Date: April 28, 2006

To: T10 Committee (SCSI)

From: George Penokie (IBM/Tivoli)

Subject: SAM-4: Converting to UML part 1

Figure 4 — Logical unit class diagram

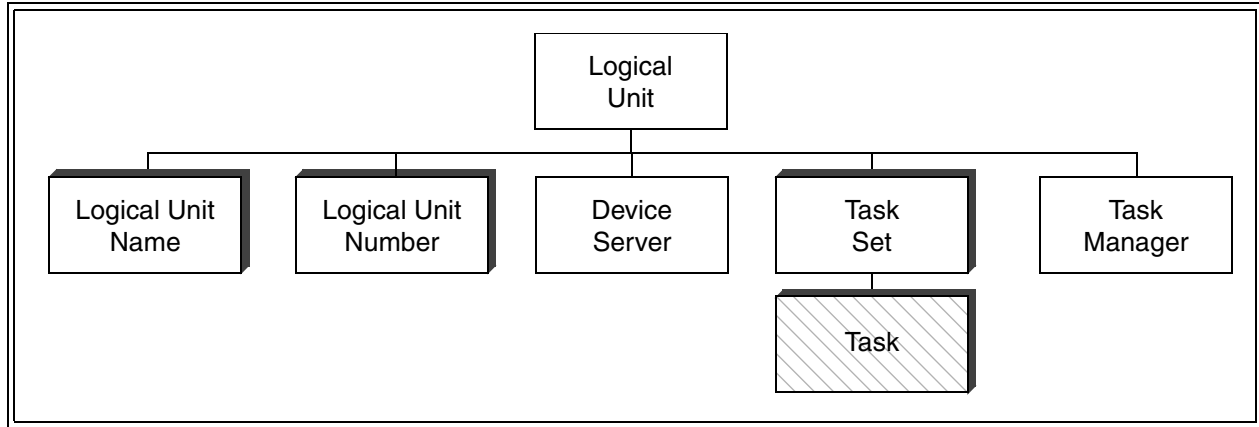
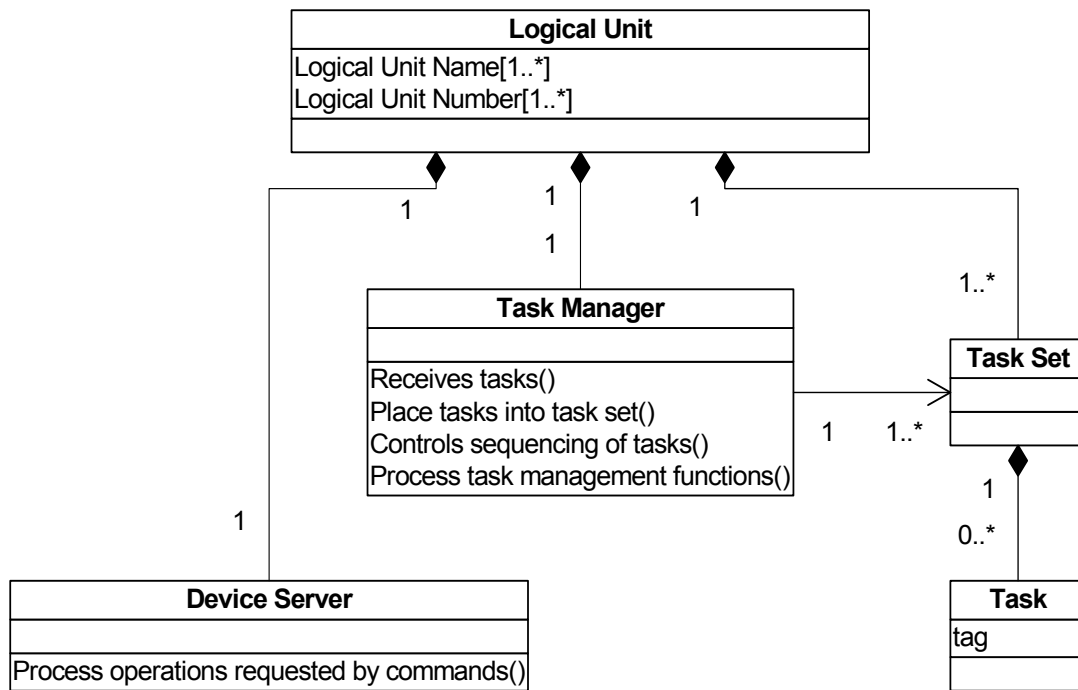
For an example of what figures in SAM-4 would look like a converted logical unit model (see figure 3) as currently shown in SAM-4 would look like what is shown in figure 4.
